**SAN ANTONIO WATER SYSTEM
HIGHLAND ESTATES, UNIT 1 P.U.D. MONTANA PASS FLOATING GROUND
STORAGE TANK PROJECT**

**SAWS JOB NUMBER 15-1177
SOLICITATION NO. CO-00092**

**ADDENDUM NO. 5
October 13, 2016**

1. S.S. WEDGE ANCHORS TO BE USED TO CONNECT HANDRAIL BASE PLATES TO THE TANK FLOOR
2. ALL S.S. TO BE ISOLATED FROM CONCRETE USING NEOPRENE GASKETS.
3. TOE BOARD TO BE PROVIDED ON ALL SIDES OF PIPE.
4. REMOVABLE RAILING. ONE SIDE OF RAILING SHALL BE REMOVABLE FOR MAINTENANCE

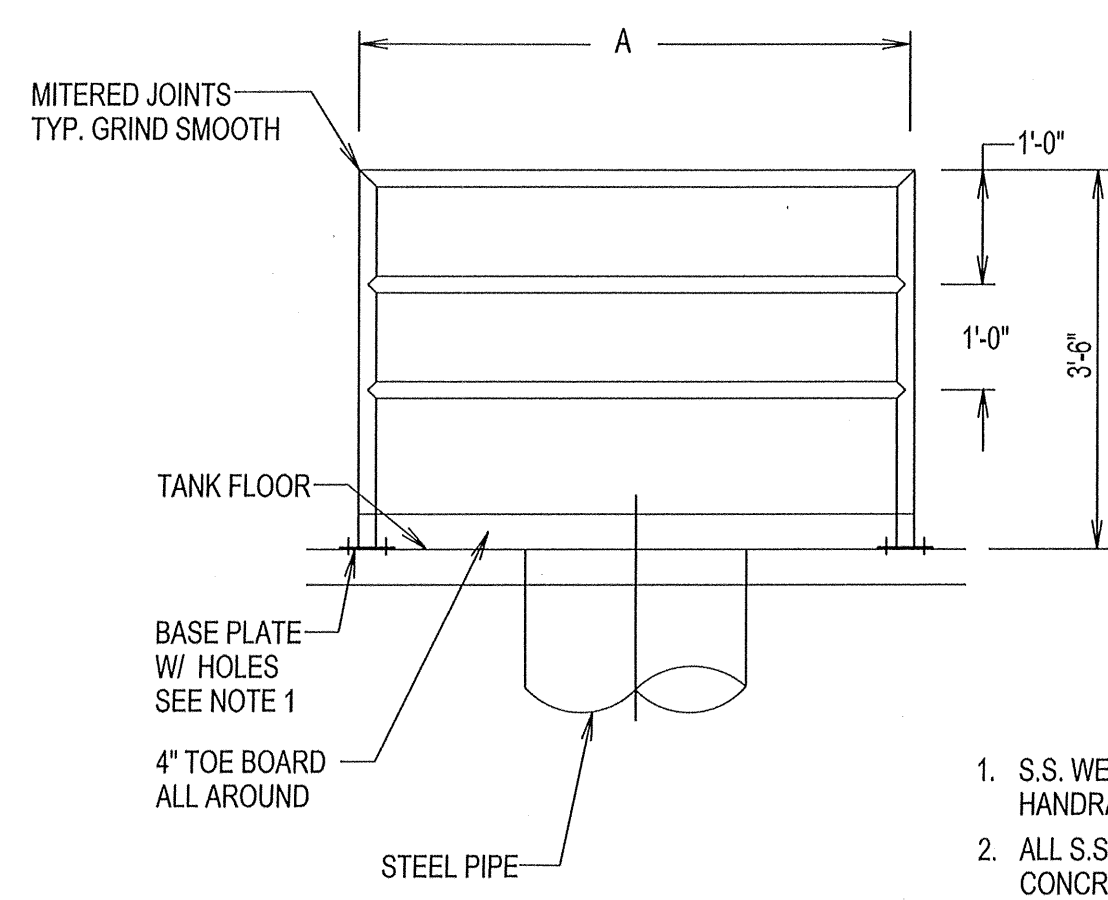
8. Sheet T-6, indicates all of the pipes shall have 3’-0” min. cover from the tank finish floor elevation. Sheets C-6.1 and C-6.2 indicate the pipes shall have 5’-0” minimum cover from finish grade. Please confirm the bury depth or centerline elevation for all tank piping.
Minimum cover on pipes shall be 5’. Refer to revised Sheet T-6R1 attached as part of this addendum.

9. Sheet T-2, please confirm the handrail material for the tank dome.
Handrail material is 1½” Schedule 40 stainless steel 316L pipe. Reference Pipe Safety Railing detail on Sheet T6R1.

No.	Revision	Drawn	Approved	Date
REVISIONS				
MONTANA PASS TANK AND BOOSTER STATION PROJECT				
OVERFLOW AND DRAIN LINE DETAILS				
DEVELOPER: SAWS				
CONT.		BUDGET PROJ.		
SUBMITTED _____				
APPROVED _____				
MAP No.				SHEET
SECT. No.				T-7R1
DR.	CK.	JOB No. 15-1177

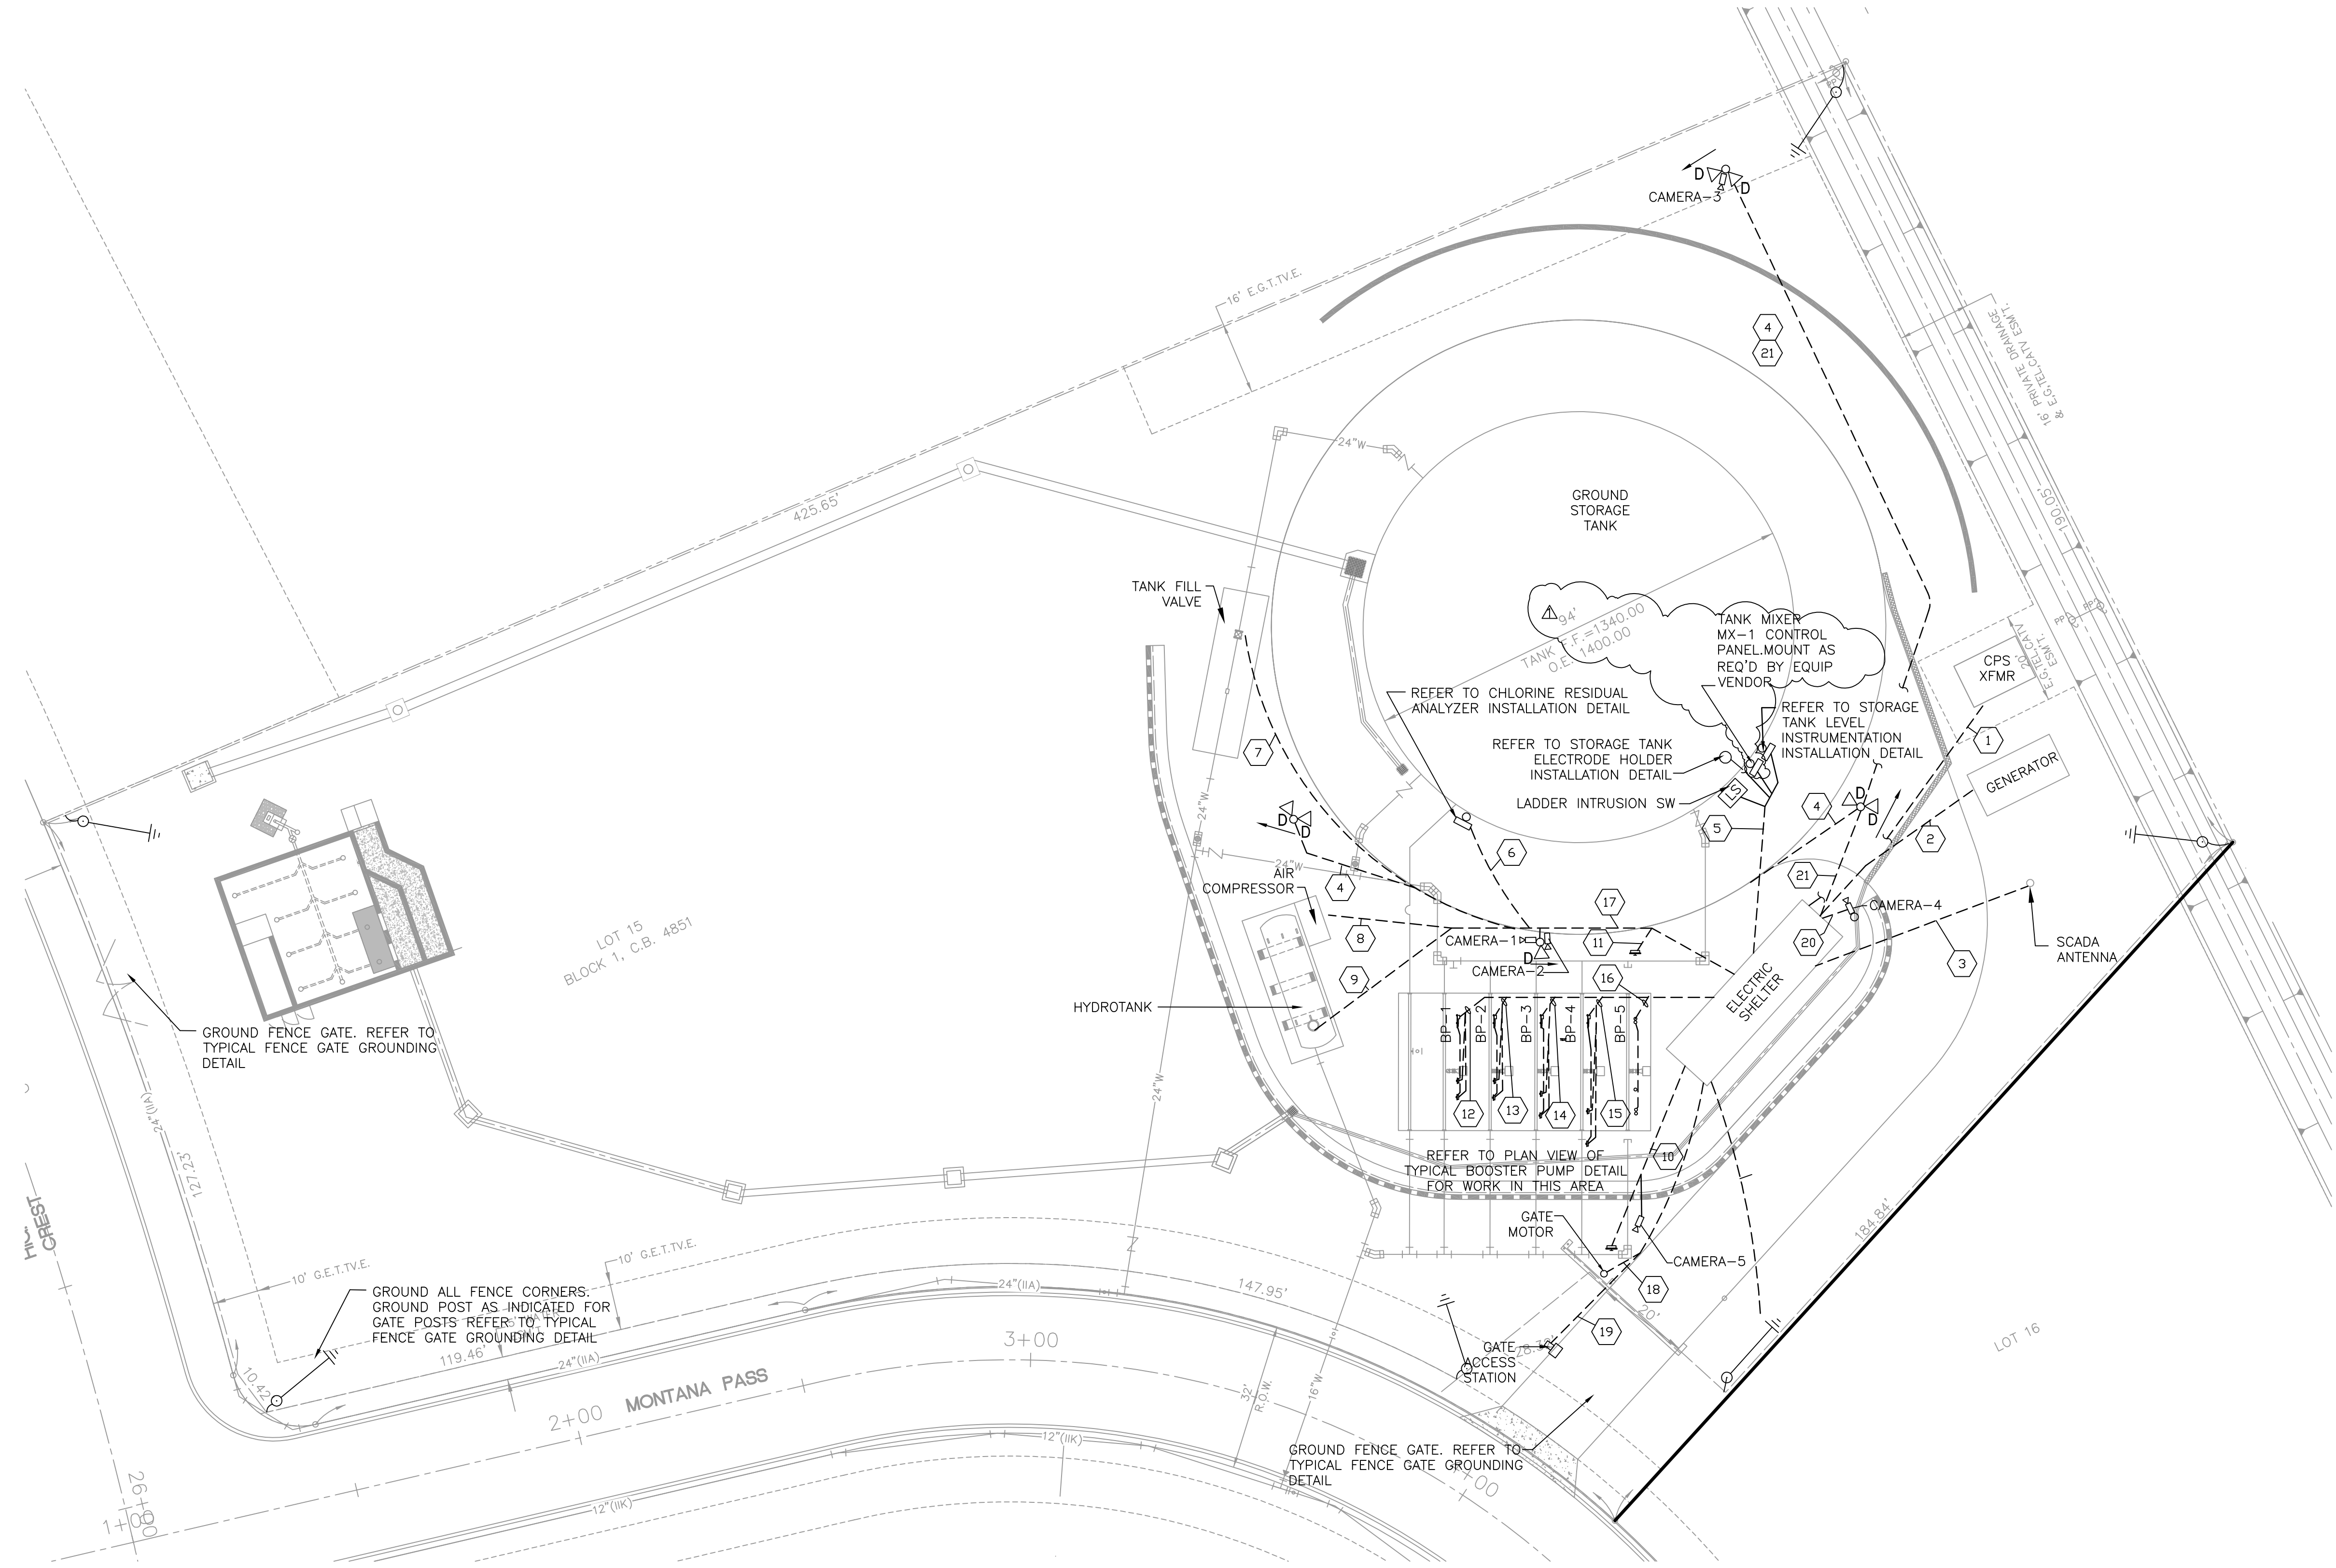
4. Section 13205, Page 9, Article 2.09.A.5, indicates a 30-inch overflow pipe; however, the note on Contract Drawing T-7 indicates tank manufacturer is responsible for final

design. Please confirm tank manufacturer is responsible for final sizing of overflow weir and pipe based on the specified overflow rate.

The engineer is responsible for the overflow piping design as indicated in T-7 R1. SAWS details indicate that the overflow piping and overflow drain shall be sized by the engineer. The tank manufacturer is responsible for the tank weir design.

STORAGE TANK ELECTRODE HOLDER INSTALLATION DETAIL
NTS

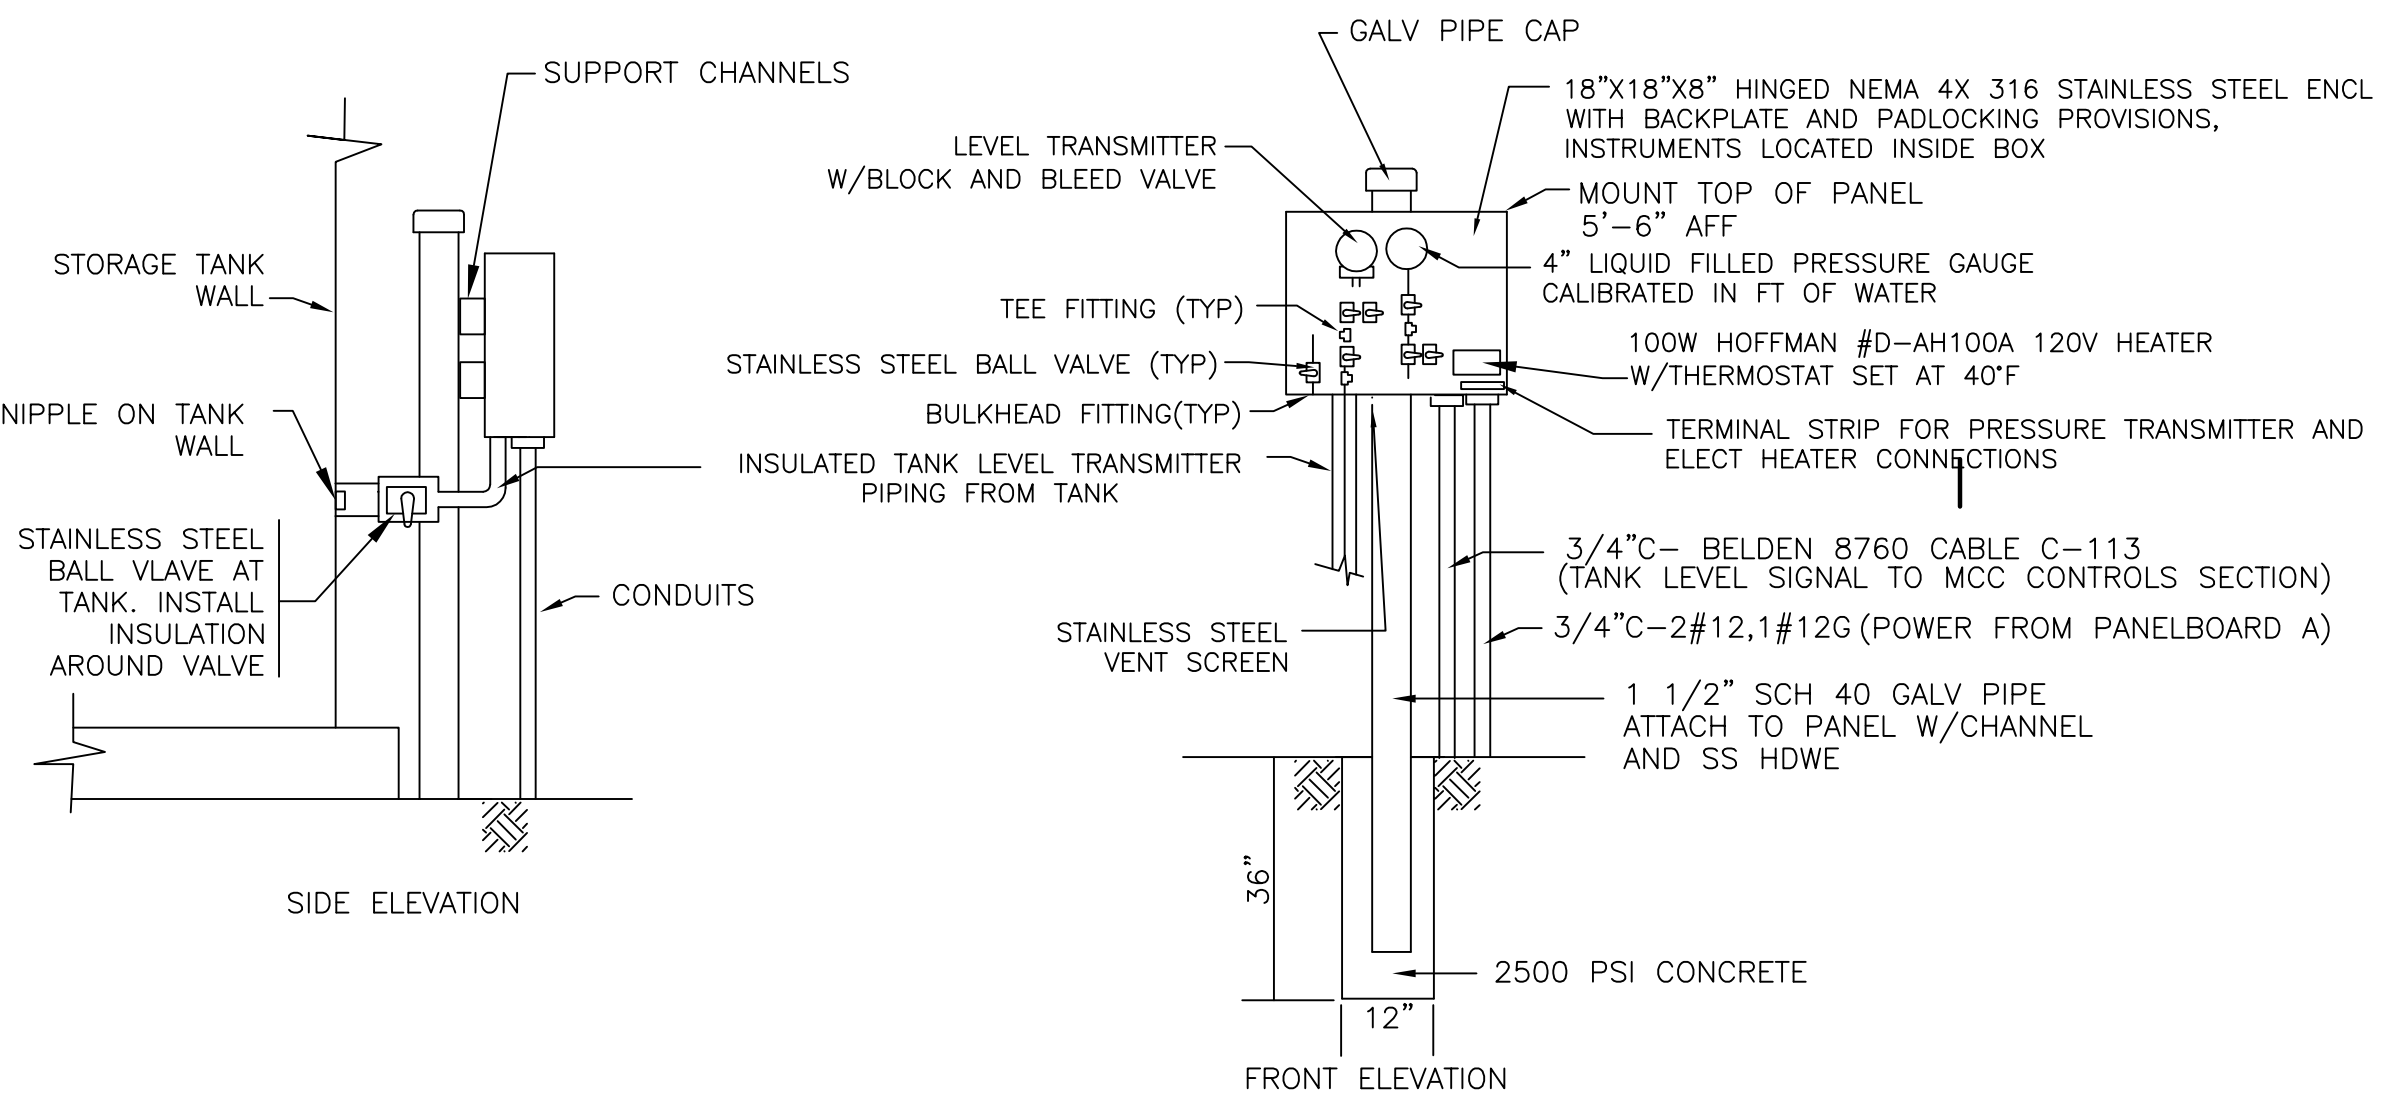
30. Drawings T-2 and E-2 refer to dome sleeves for electrical connections to instrumentation inside the tank. We recommend using precast concrete curbs with 8" diameter PVC pipes with flanges and PVC blind flanges for these dome penetrations. Please confirm precast concrete curbs with 8" PVC pipes, PVC flanges, and PVC blind flanges are acceptable for this application.

No precast concrete curbs with 8" PVC pipes will be allowed for dome penetrations as they are not in compliance with typical SAWS standards. Refer to E9 for electrode holder detail.
